# ADDENDUM NO. 2

June 11, 2021

## Provo Peaks Elementary Re-Roof

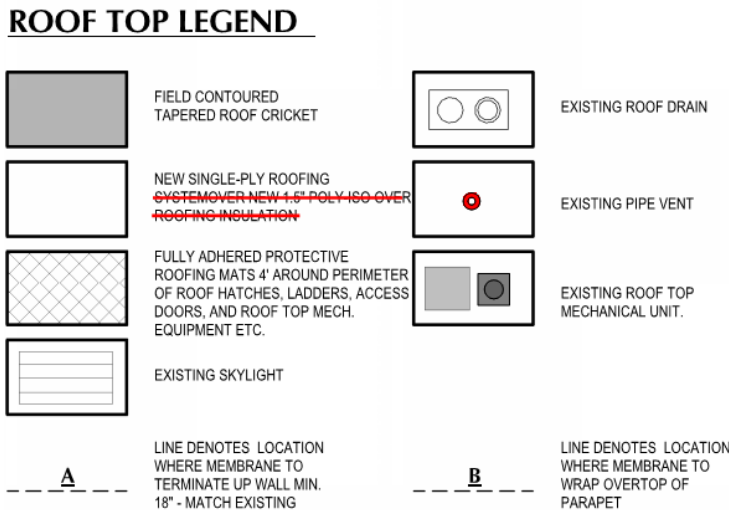
1. **Sheet A001 Sheet Note 1.01 & Roof Top Legend** – Delete 1.5" poly-iso roofing insulation from the roof top legend. Per image below. The intent of this project is to replace the membrane not the roofing insulation. That being said per Addendum 1 that is now on the districts website we do ask for a unit price for insulation if you encounter damaged insulation that needs to be replaced. If that happens the unit cost will be used to determine the change order based on the amount that needs to be replaced.
